This page lists the know errors on the gm5x5x5 PCBs. There are no known issues with the bulk order run (white pcbs), the following information is valid **only** for the prototype run (green pcbs).

## **Bulk Order #1 (white pcb, rev 1.0)**

## **Prototype Run (green PCBs)**

### **#1 MIDI IO pins**

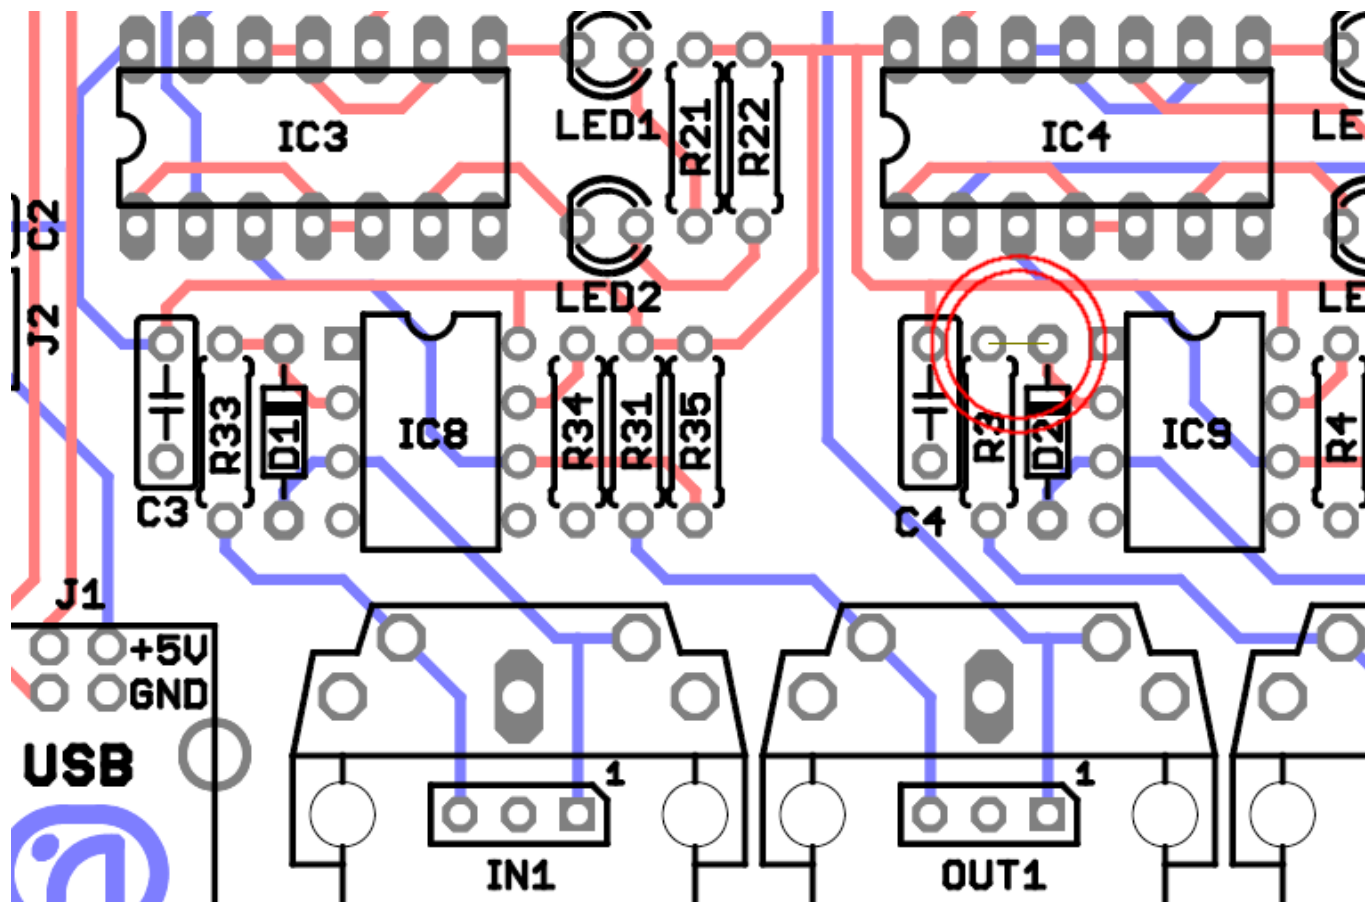
**Problem:** The MIDI IO pins of the midi sockets (Pin 4 + 5) are switched.

**Solution:** Either (1) use the pin-headers if you use sockets that are not mounted on the pcb or (2) break the traces to pins 4 + 5 of the sockets and solder wires to them or (3) solder the midi sockets on the other side of the pcb.
